Re: Comments on Environmental Assessment for Scotts Valley Casino and  
Tribal Housing Project

This letter and its attachments and enclosures provide comments from the Yocha Dehe Wintun Nation on the Environmental Assessment ("EA") prepared for the Scotts Valley Casino and Tribal Housing Project ("Project").

**DETAIL D**  
**EARTHEN SWALE PROFILE**  
**(ADJACENT TO NORTHWEST**  
**CORNER PROPOSED BUILDING)**  
 FOR  
**SCOTTS VALLEY**

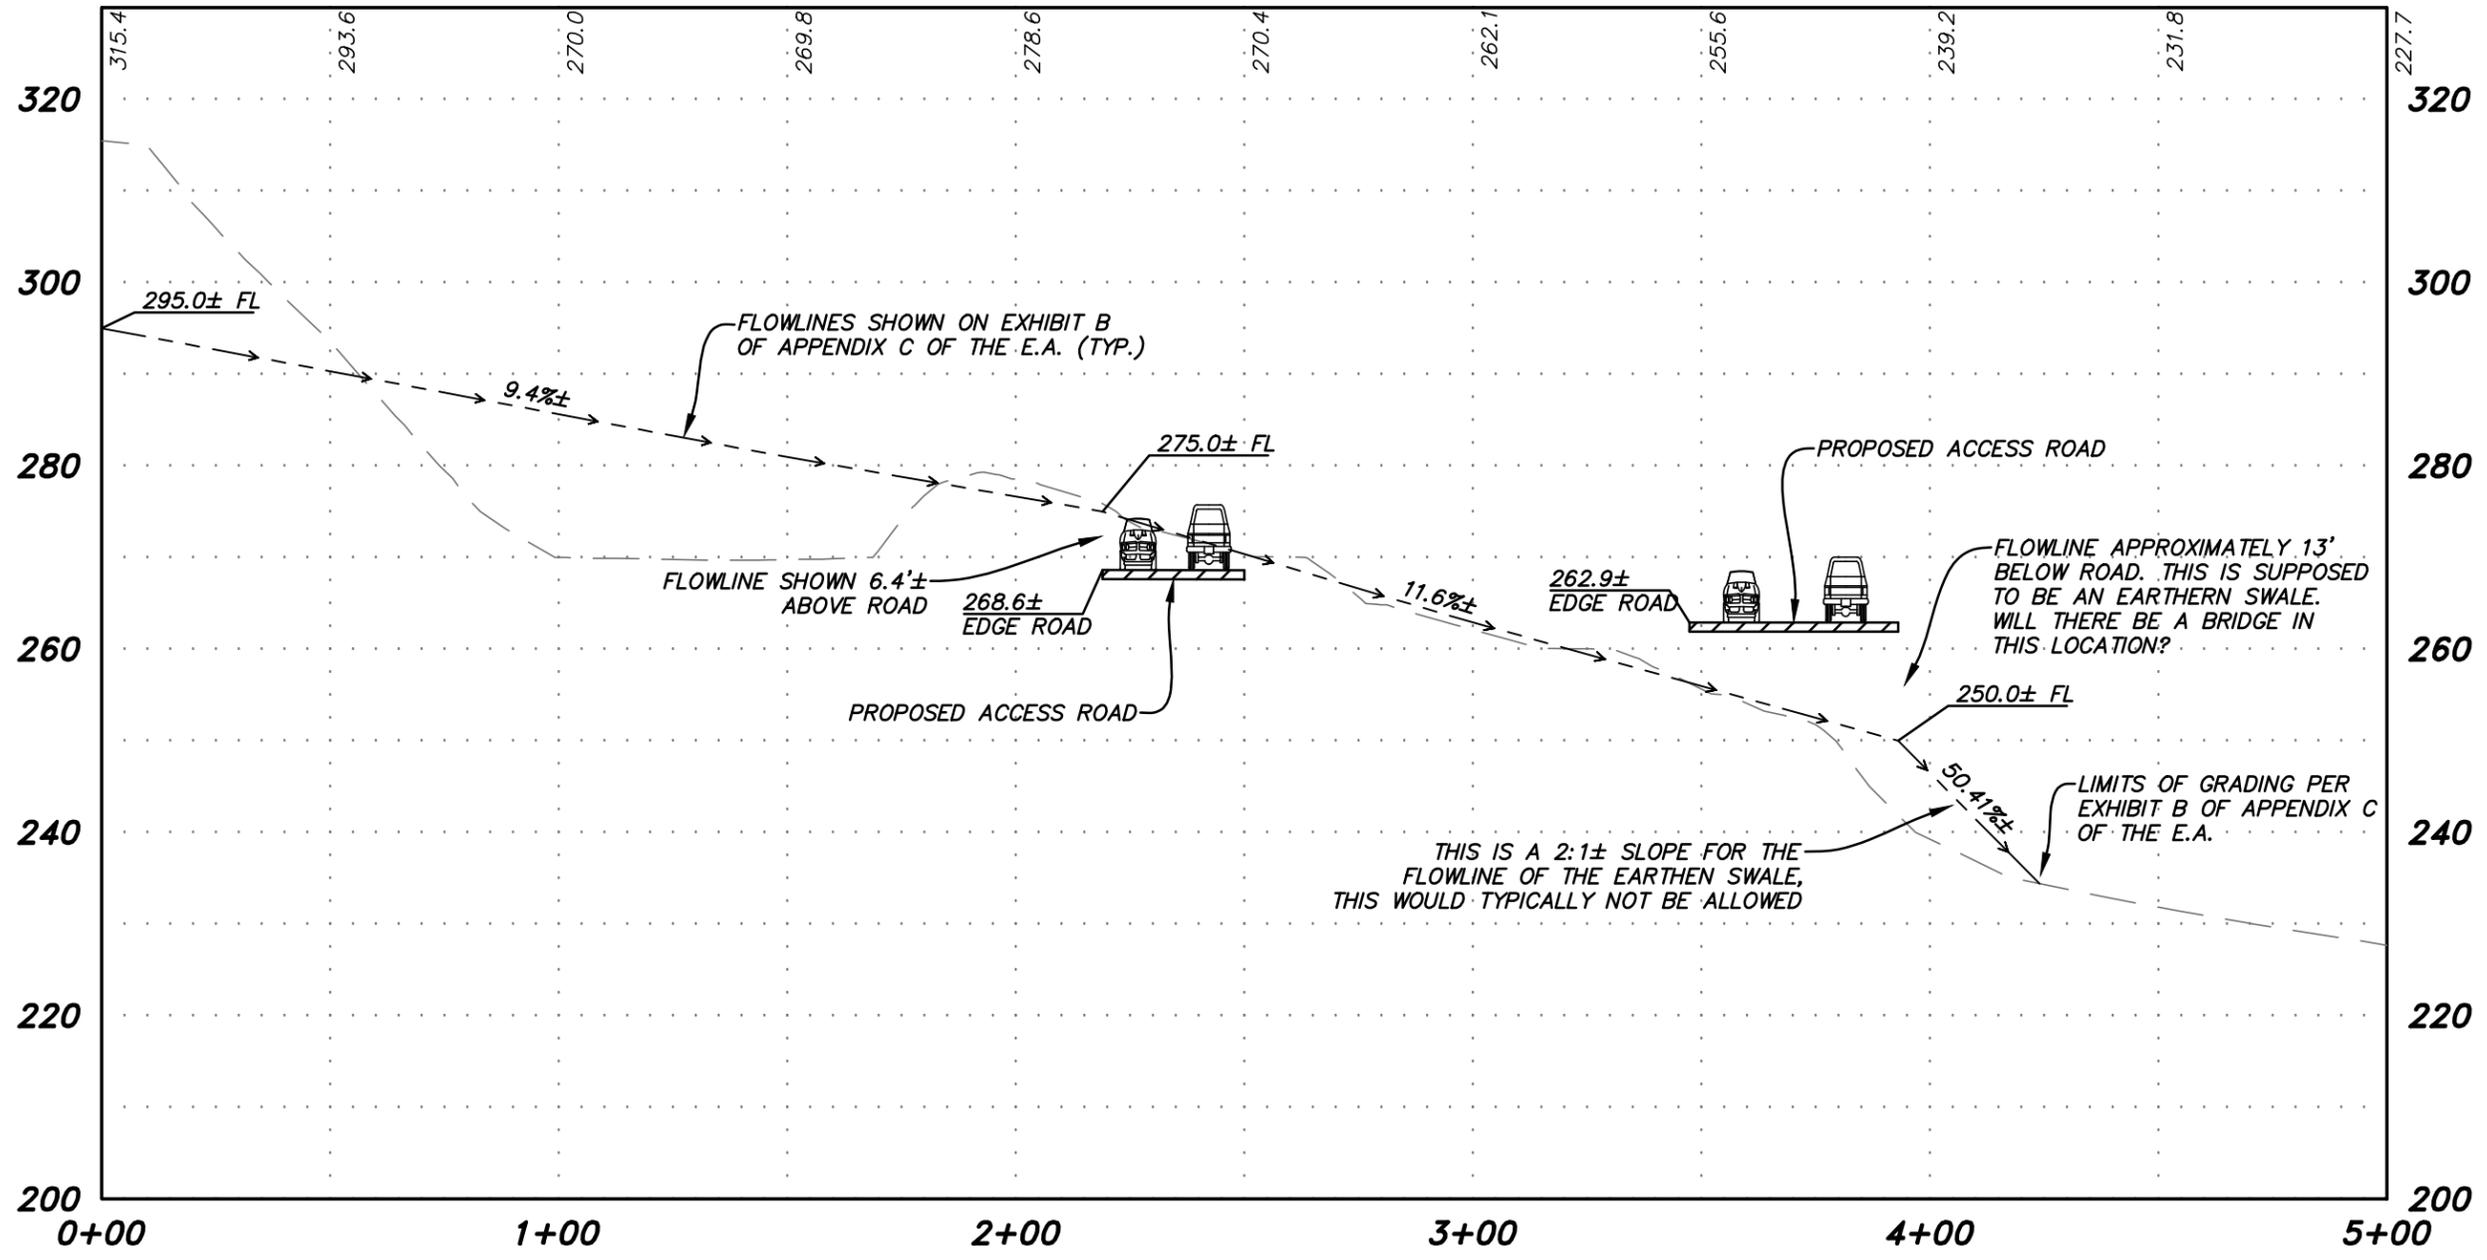
- In suggesting that drainages will be maintained in a natural, vegetated condition, the EA ignores the actual Project design. The swale shown flowing under the access road near the northwest end of the casino structure is too deep to construct; the drainage would need to be placed in a culvert. More generally, earthen swales cannot be constructed at the depths suggested while maintaining the width shown on Project plans – they are not constructable, and they would be too steep and too deep to serve their intended purposes. To maintain structural and environmental

integrity, the swales would need to be flattened and widened, neither of which is possible under existing plans.
